URGENT FIELD SAFETY NOTICE

GE Healthcare

GEHC Ref# 32072

RE: Giraffe Blue Spot PT Lite Phototherapy Systems—Light Output May Fall Below the Recommended Minimum Output Due to Fiber Protrusion.

Normal / Focused Output Light

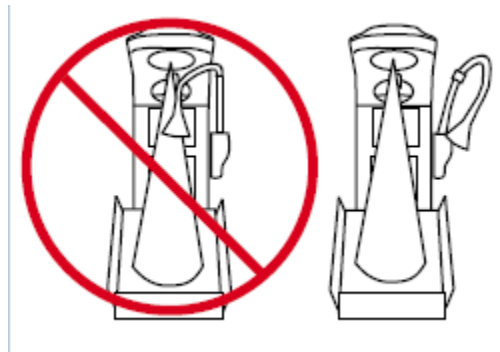
Elevated heat can cause the light pipe optical fiber to protrude through its reflector aperture, creating an unfocused spot with less than $27\mu\text{W}/\text{cm}^2/\text{nm}$ output as described above. The photos below show the effect and can be used in conjunction with the BiliBlanket Meter II bilimeter to identify units with a low light condition due to elevated heat exposure.

Shade is 15 in. (38 cm) from mattress pad
 Output has well-defined edges
 Output is a 14 in. (35.5 cm) dia. circle
 Light intensity uniform

Abnormal / Unfocused Output Light

Shade is 15 in. (38 cm) from mattress pad
 Output has diffused, ill-defined edges
 Output is a 16-19 in. (40.6-48.2 cm) dia. circle
 Dull center surrounded by an intense band

Take out of service any units found to have irradiance levels less than $27\mu\text{W}/\text{cm}^2/\text{nm}$ and await the free kit to correct the unit that GE Healthcare will be sending for all potentially affected units.
